APPENDIX A
SHADE AND SHADOW ANALYSIS

21 UNIT CONDOMINIUM 556 EL CAMINO REAL BURLINGAME, CA
FOR ROMAN KNOP 261 17TH STREET SAN FRANCISCO, CA 94121
PH: (415) 516-5180

RE: Shadow Analysis Peer Review
556 El Camino Real Condominium Development

SHADOW STUDIES

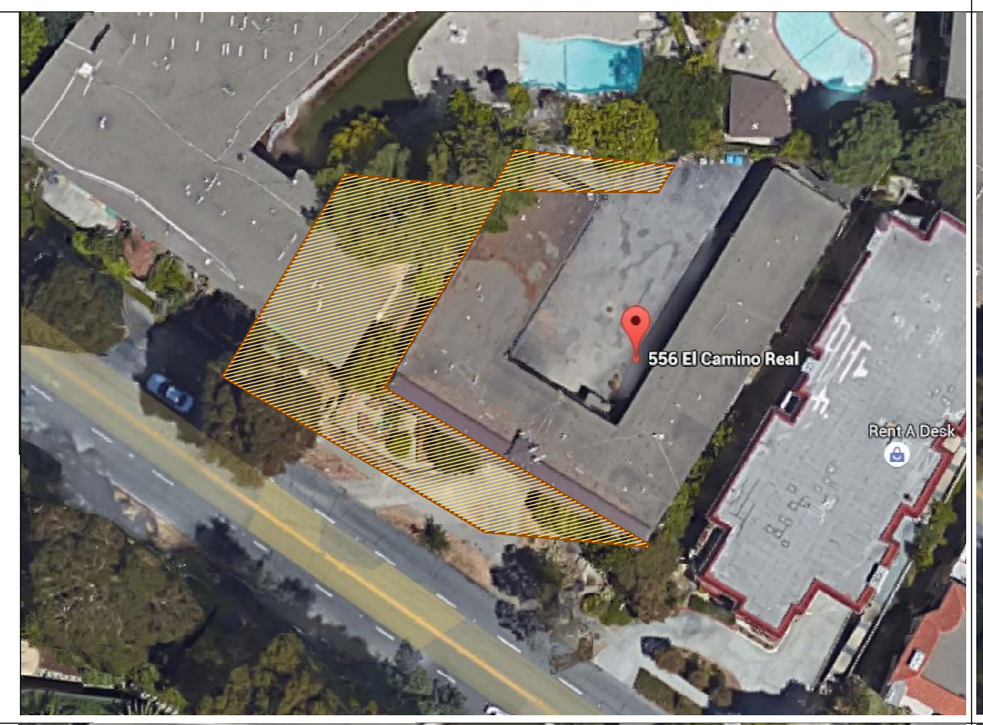
DJP&A has reviewed the Shadow Study Summary provided to the City of Burlingame by Vadim Melik-Karamov, President of VMK Design Group on August 24, 2015. DJP&A independently calculated and plotted the anticipated shadows cast by the proposed building and found the shadow study provided by the architect to be accurate. The Burlingame Downtown Specific Plan specifically states that shadow diagrams should be evaluated for 9 AM, 12 noon, and 3 PM to determine impacts to major pedestrian routes for the autumnal and vernal equinoxes as well as the summer and winter solstices. The shadows cast by the proposed building at these times would not significantly increase shadows on the adjacent public sidewalk along El Camino Real (refer to Figures A, B, and C).
